Office Action Summary	Application No.	Applicant(s)	
	09/934,549	LIN CHENG	
	Examiner	Art Unit	
	Hanh V. Tran	3637

DETAILED ACTION

Application No. 09/934,549
Inventor: Lin Cheng
"Reticle Box Transport Cart"
Replacement Sheet 1 of 1

Fig. 2

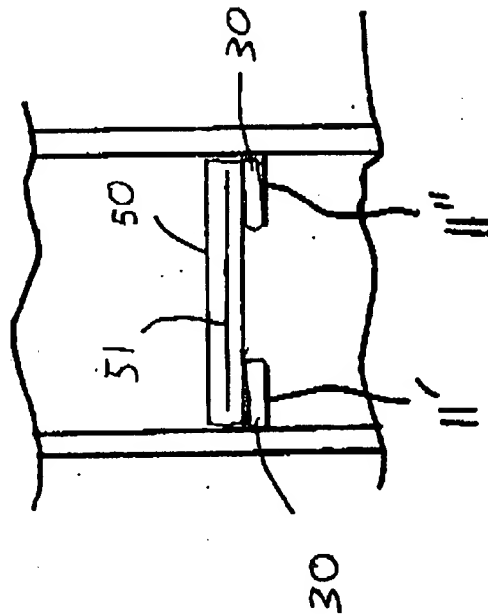
Acceptable!
MVT 5/21/08
